Levy County Units 1 and 2 COL Application

Staff Presentation to
ACRS Full Committee

December 1, 2011

Pre- and post-grouting seismic wave velocity measurements (AFSER Figure 2.5.2-9)

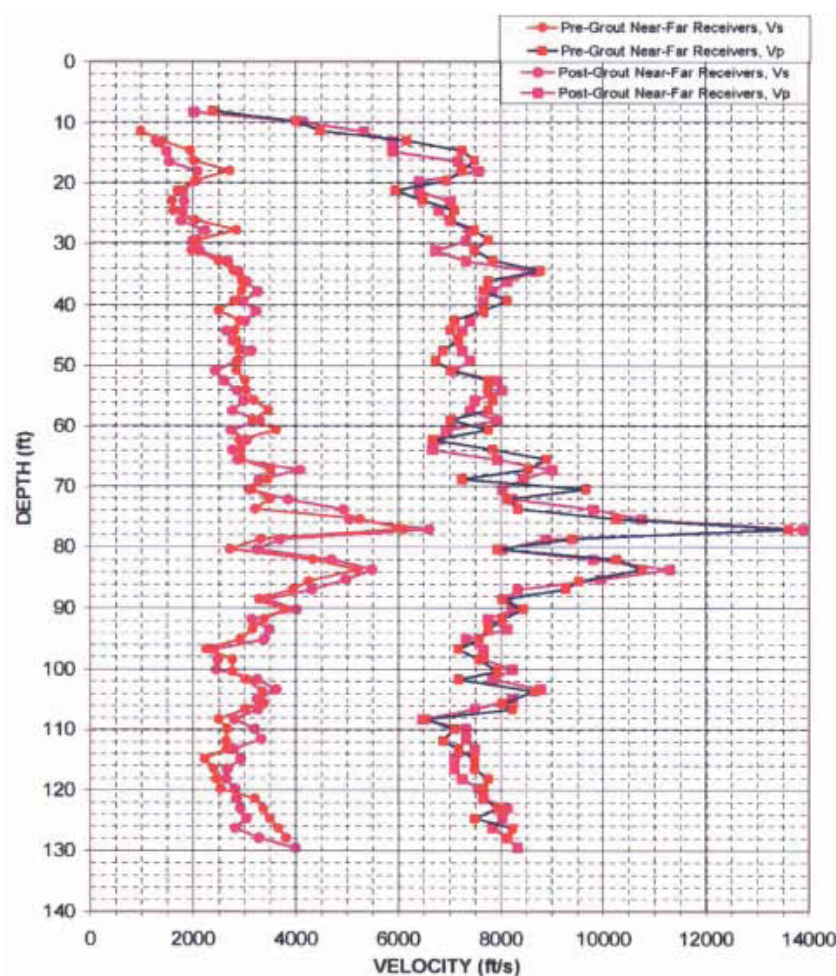
- Issue: Staff was concerned that seismic wave velocities are the same before and after the applicant's grouting program.
- Resolution: Applicant's grout test program measured velocities pre- and post-grouting. Measurements demonstrate that the grouting program do not alter the measurements of seismic wave velocities. Therefore, this issue is resolved.

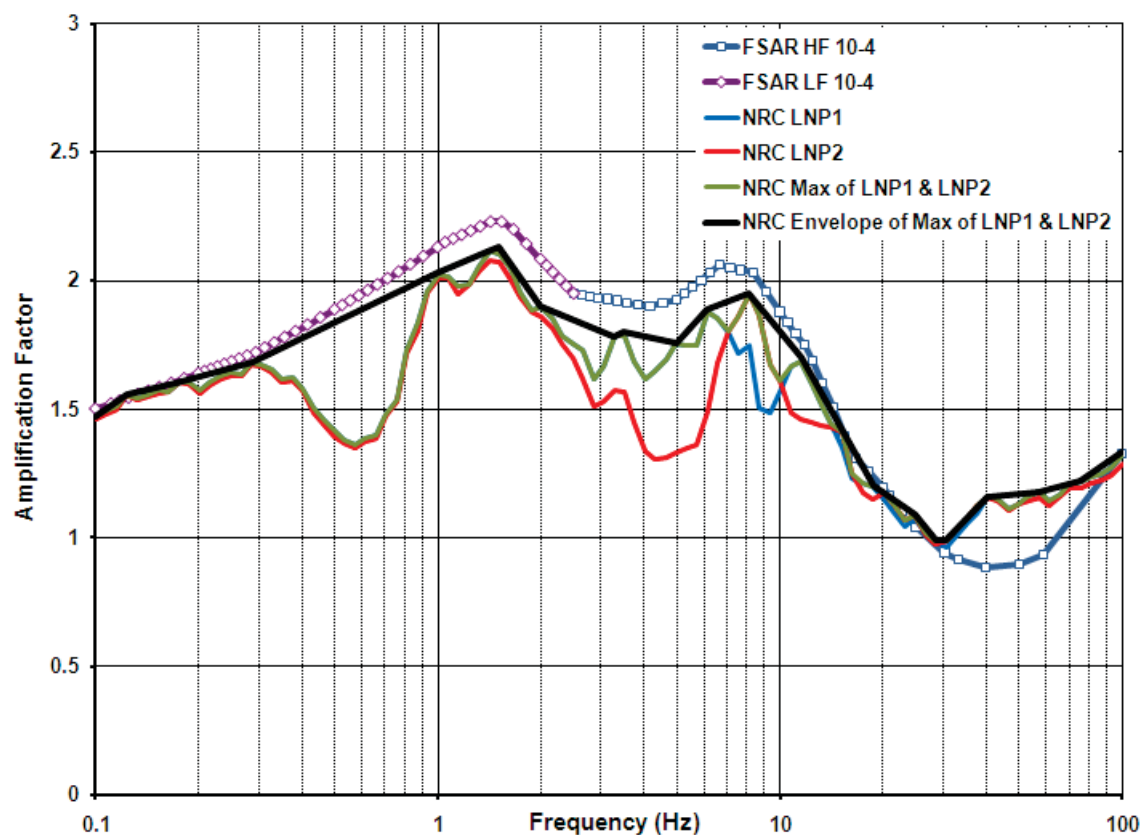
- Site amplification functions were calculated for both LNP Unit 1 and 2 profiles and later enveloped to provide a conservative estimate.
- NRC Staff performed an independent site response analysis and confirmed the applicant's results.
